TRUCK UTILITY LIGHTWEIGHT MC2
LANDROVER SERIES III ALL TYPES
REWIRING OF HEADLIGHT CIRCUIT

MODIFICATION INSTRUCTION

FIG 1 - CIRCUIT DIAGRAM OF LANDROVER SERIES 3

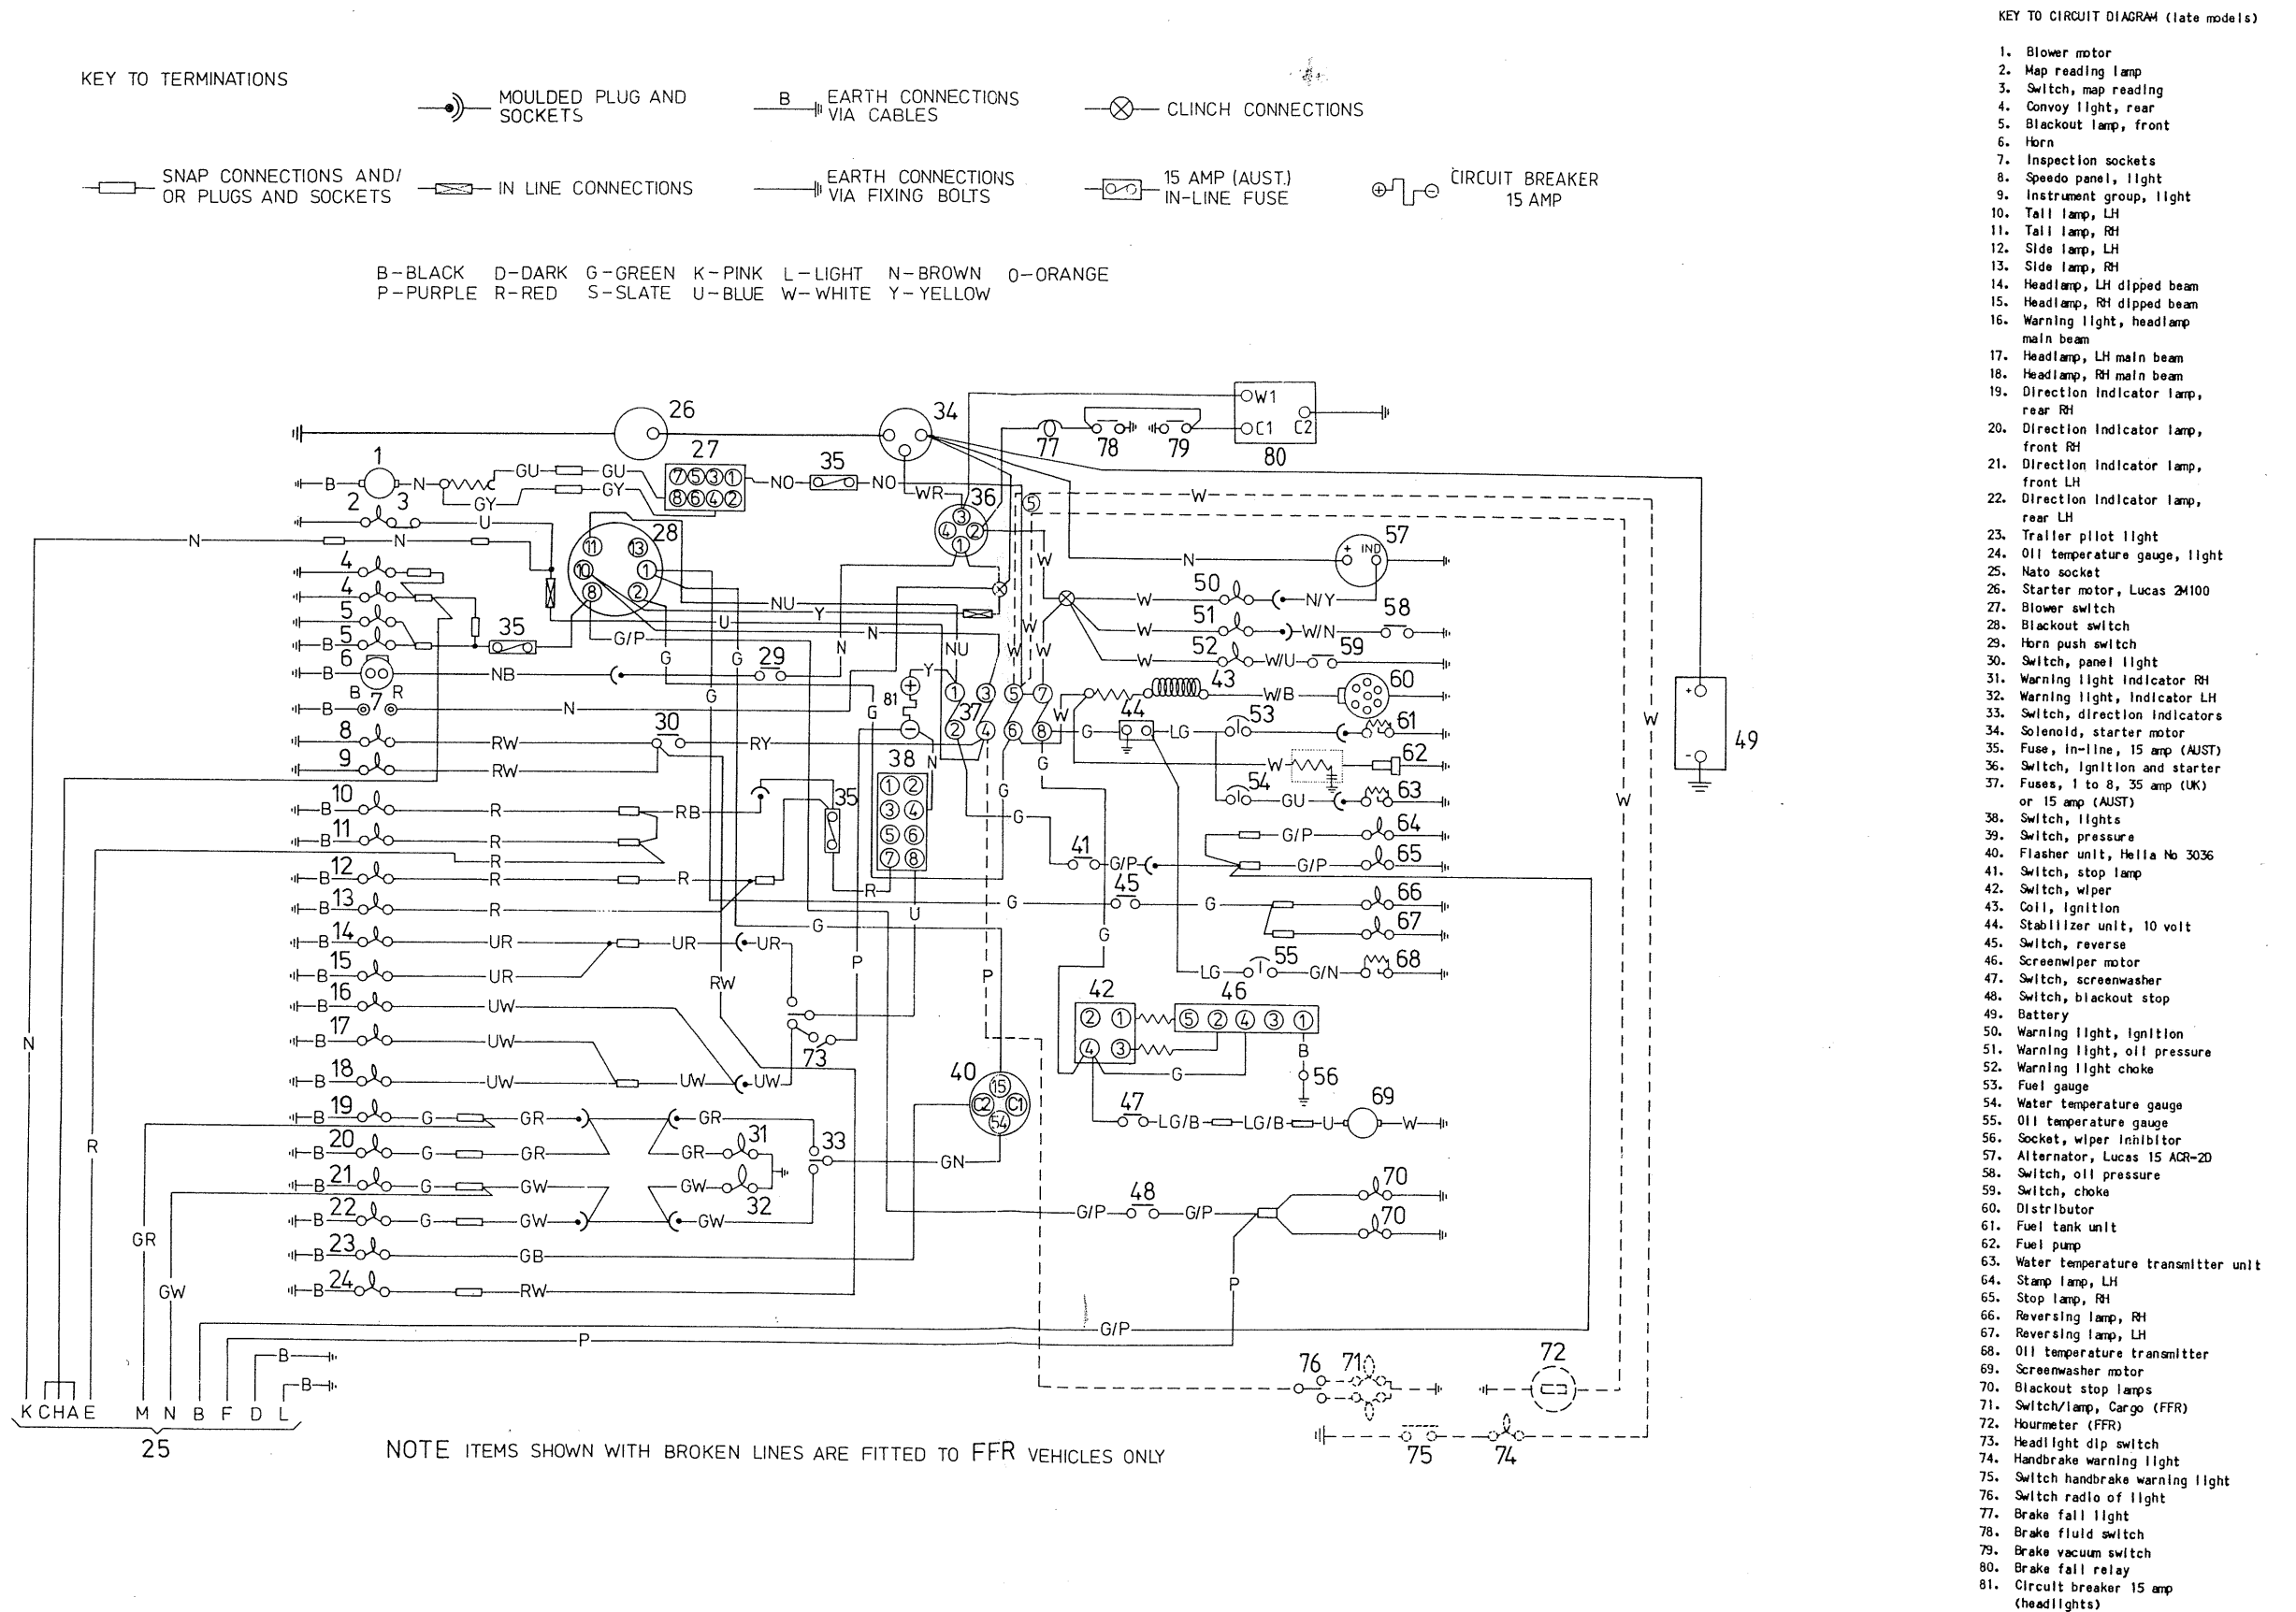
1. Instances have occurred where the plastic surrounding pins 3 and 4 in the fuse box have melted.
2. This modification details the fitting of a circuit breaker to the headlight circuit to prevent the fuse box melting while the headlights are on for an extended period. This instruction is to be read in conjunction with EMEI VEH G 303-1 and G 307-13.

- c. Remove the power feed wire (brown wire) from terminal 3 of the fuse box and re-route to terminal 10 of the blackout switch, (terminal 2 of santon type switch). Use items 1 and 2 of Table 1 to lengthen the power feed wire.

- d. Remove the map light wire (blue wire) and auxiliary power feed wire (brown wire) from terminal 10 of the blackout light switch, (terminal 2 of santon type switch) taking care to remove the correct brown wire.

- e. Identify the brown wire connected between terminal 4 of the fuse box and terminal 10 of the blackout switch (terminal 2 of the santon type switch). Disconnect this wire from terminal 4 and reconnect to terminal 3 of the fuse box.

- f. Using items 4, 5 and 6 of Table 1, join the map light wire and the auxiliary power feed wire and re-route to the fuse box terminal 4.
 - g. Mount the circuit breaker (item 7 of Table 1) to the flasher can mounting screw.

- h. Using items 2, 3, 4 and 6 of Table 1, join the positive terminal of the circuit breaker (item 7) to the fuse box terminal 1.
 - i. Disconnect the high beam flash feed wire (purple wire) and the headlight feed wire (brown wire) from the fuse box terminal 1 and re-connect both wires to the negative terminal of the circuit breaker (item 7).

- j. Check that the modified wiring corresponds to that shown in Fig 1 and reconnect the battery.
 - k. Test the operation of headlights in both normal and blackout modes.
